Engine control unit ground screw tightening
Models: M.Y. '10 F1098S STREETFIGHTER
Recall Bulletin RCL-09-006

Date: Tuesday, September 22, 2009
To: Dealer Principal, Service Manager, North American Dealer Network
From: Austin Gray, Technical Director; Jonathan LaForte, Technical Manager

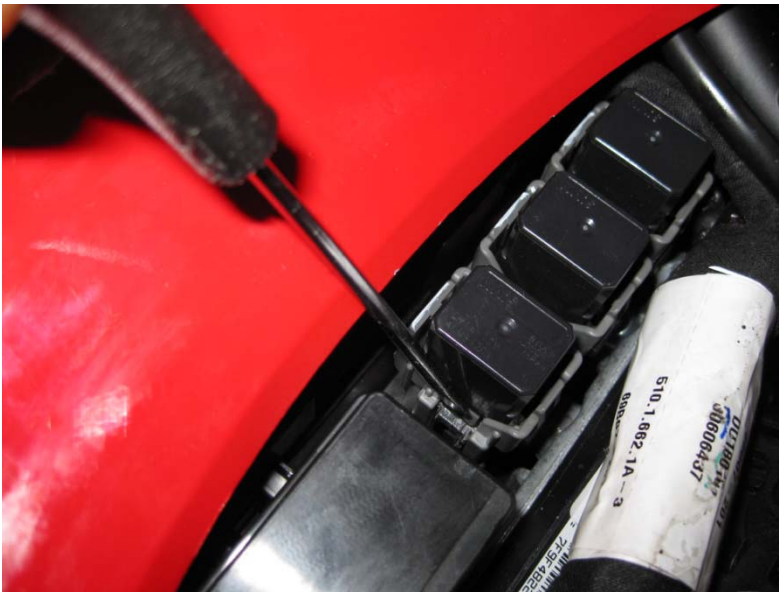
- 1) Remove the seat
- 2) Remove the relay mount as shown
